STAFF RECOMMENDATION

1410 Lillian Street

February 18, 2015

Application: New construction-infill and detached accessory dwelling unit; Setback determination

1 Proposed Site Plan

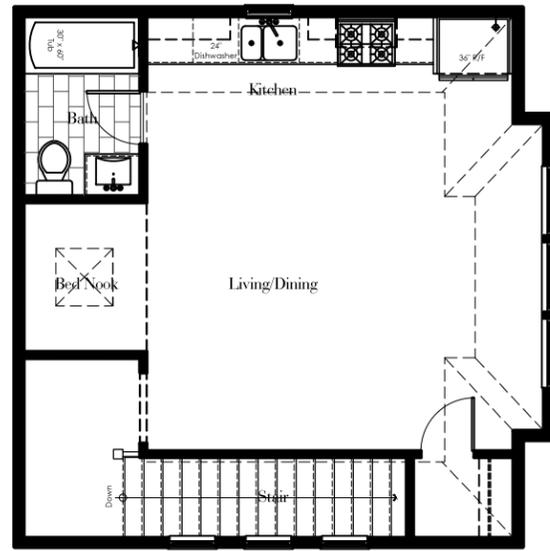
Setback & Rhythm of Spacing: Because of the fifteen-foot (15') wide sewer easement on the right side, the proposed infill will be shifted to the left side of the lot. The applicant is requesting a setback determination for the left side property line. Base zoning requires that primary structures be located a minimum of five feet (5') from the side property line, and the applicant is proposing to situate the structure just three feet (3') from the side property line. Staff finds the three foot (3') side setback to be appropriate in this instance because the sewer easement restricts the location of the infill, and if the applicant were to meet the five foot (5') side setback, the width of the infill would be narrower than the historic context. The new side setback would place the new infill approximately eight feet (8') from the side wall of the house at 1412 Lillian Street.

The infill's front façade will be set back approximately forty-two feet (42') from the front property line. This matches the front setback of the house previously on the lot, and the front setback of the non-contributing house next door at 1408 Lillian Street. It is set back approximately thirteen feet (13') further than the front wall of the new duplex construction to its left at 1412 Lillian, which was constructed prior to the conservation overlay. Staff finds that the proposed front setback is appropriate as it matches the majority of the structures on this block of Lillian Street.

① East Elevation

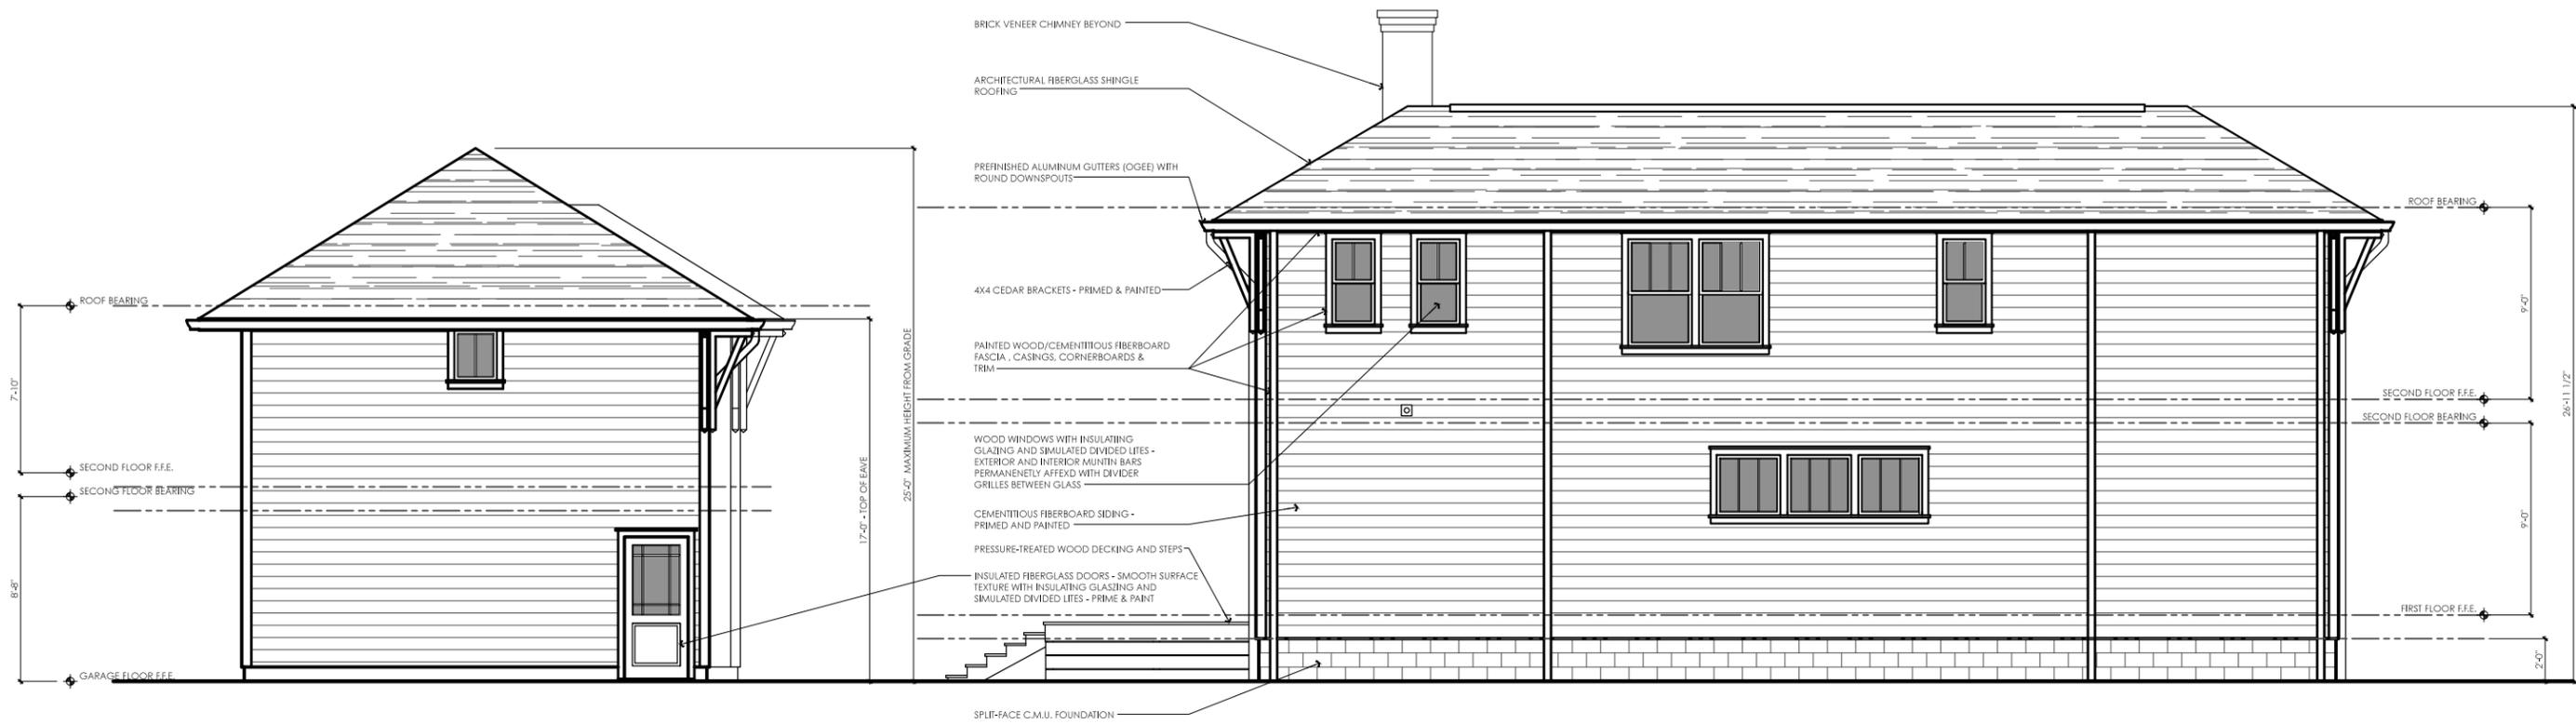
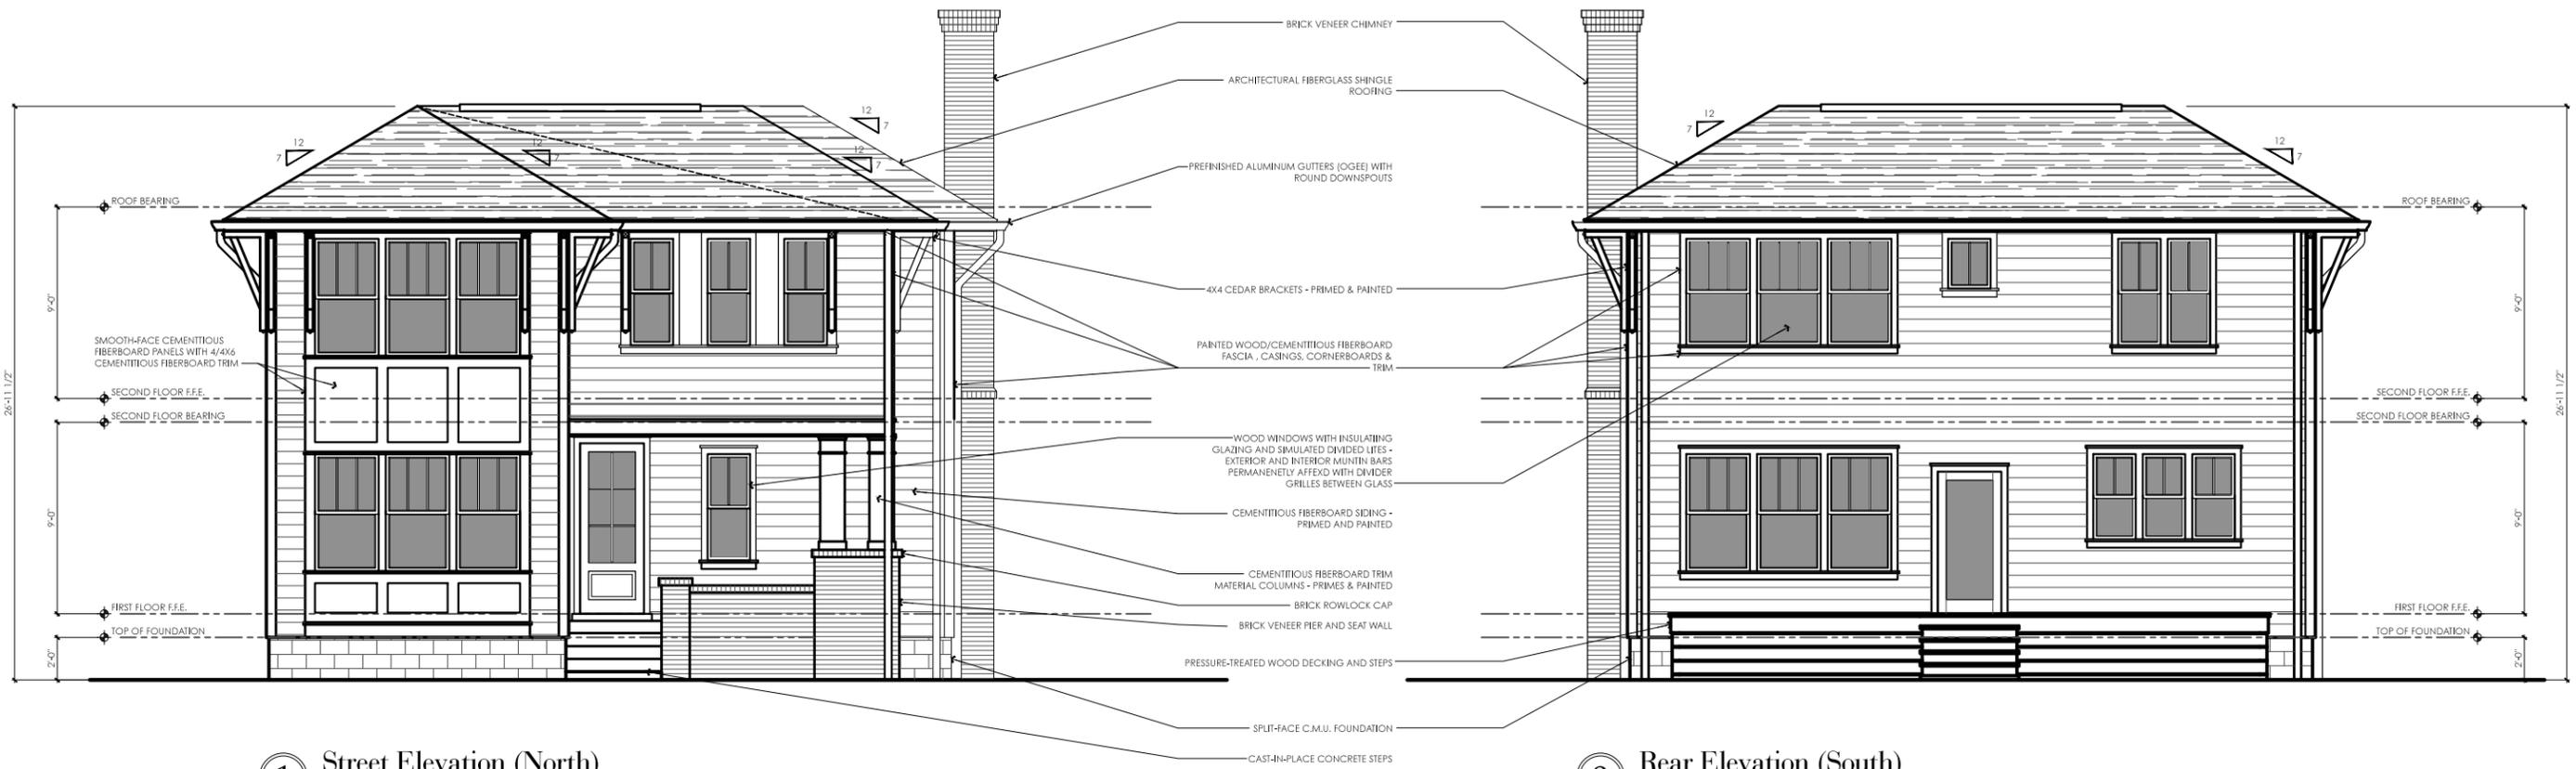
Proportion and Rhythm of Openings: The west/right elevation has more articulation than the east/left elevation. This appropriate since the west/right elevation will be highly visible because of the easement and the east/left wall will only be minimally visible because of the three foot (3') side setback.

The primary windows on the proposed infill are generally twice as tall as they are wide, meeting the historic proportion of openings. On the east/left elevation, near the front of the house, there are expanses of wall space of approximately eighteen feet (18') on the ground floor and fifteen feet (15') on the second story without a window or door opening. Staff asks that window openings of at least four square feet be added in these expanses. With this condition, staff finds the project's proportion and rhythm of openings to meet Section II.B.7. of the design guidelines.

② Garage/DADU Alley Elevation (South)

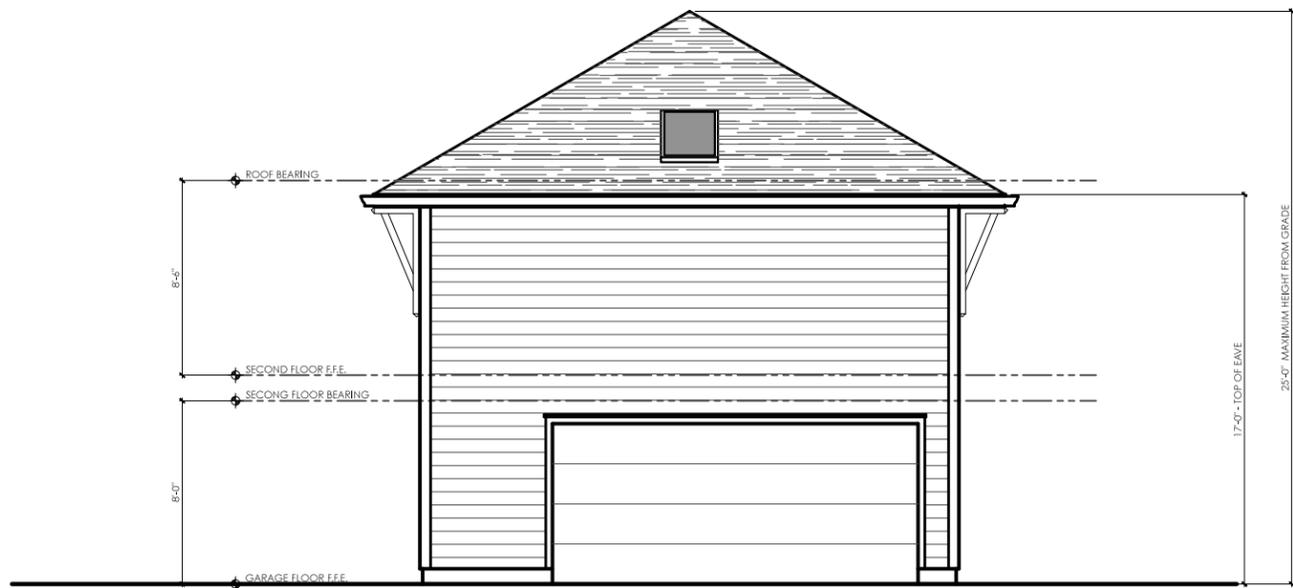
The DADU's eave height will be a maximum of seventeen feet (17'), and its ridge height will be a maximum of twenty-five feet (25'). It will meet all base zoning requirements for setbacks. The DADU's materials will match those of the infill and have all been approved by the Commission in the past. The roof will be hipped with a 7/12 pitch, and the fenestration pattern is appropriate for an accessory structure. The owner will need to submit a restrictive covenant for the DADU before staff can issue a permit for the structure.
